Permit No. 87-68

TOWN OF ACTON

APPLICATION FOR PERMIT TO CONSTRUCT WITHIN A PUBLIC WAY

SUBJECT: PERMIT TO CONSTRUCT WITHIN A PUBLIC WAY # 87-68

TOWN OF ACTON
 TRENCH DETAIL
 FEB. 1969
 NO SCALE

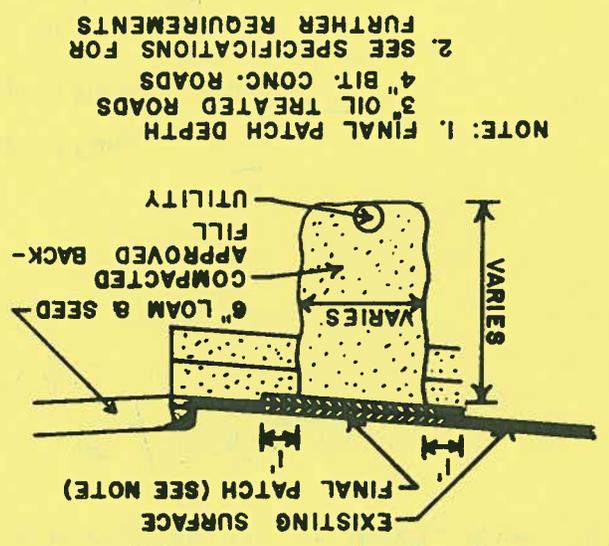
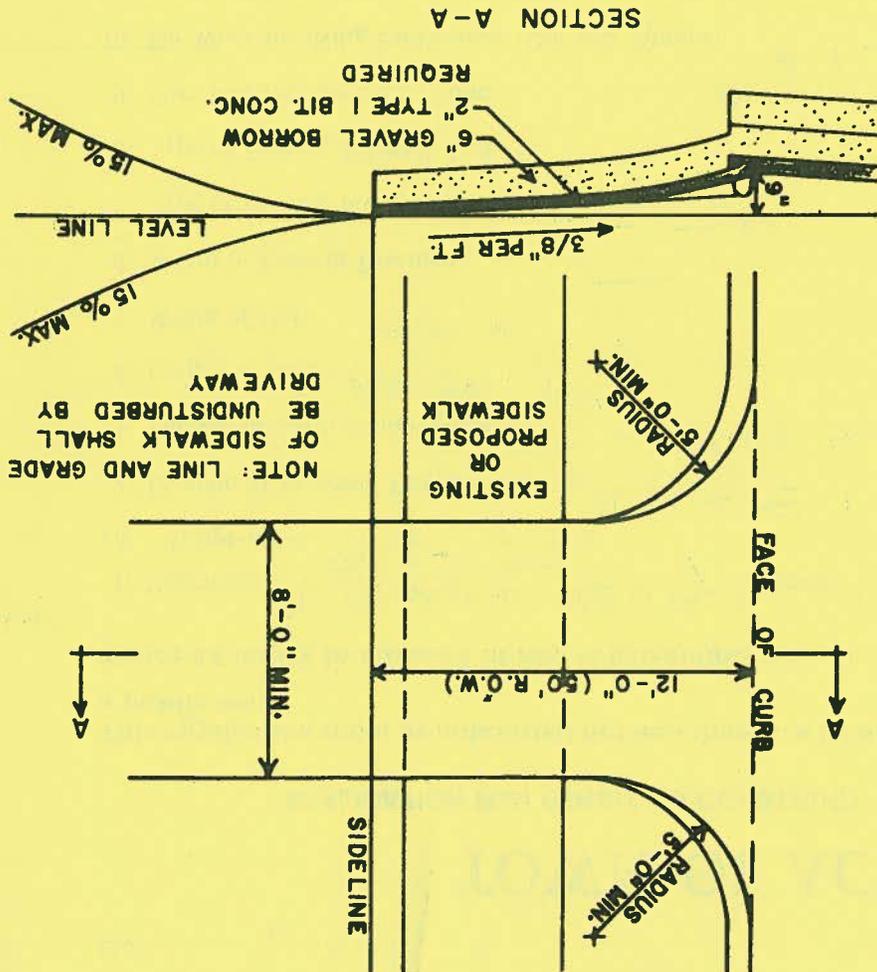
TEMPORARY PATCH INSTALLED - SLIGHT SETTLEMENT - PERMINANT PATCH REQ. FOR RELEASED BOND
INSP 4-20-86 DEO NO CHANGE

The patch you installed over the fire alarm conduit does not meet the requirements of a permanent patch as outlined in the Town of Acton Specifications for Regulating Construction Within Public Ways, section II-D-3. The patch has settled and the edges are not properly sealed. It should be removed and replaced with a minimum of three inches of bituminous concrete. A "skim-coat" over the existing patch will not constitute a proper repair.

- NOTE: 1. FINAL PATCH DEPTH
 3" OIL TREATED ROADS
 4" BIT. CONC. ROADS
 2. SEE SPECIFICATIONS FOR FURTHER REQUIREMENTS
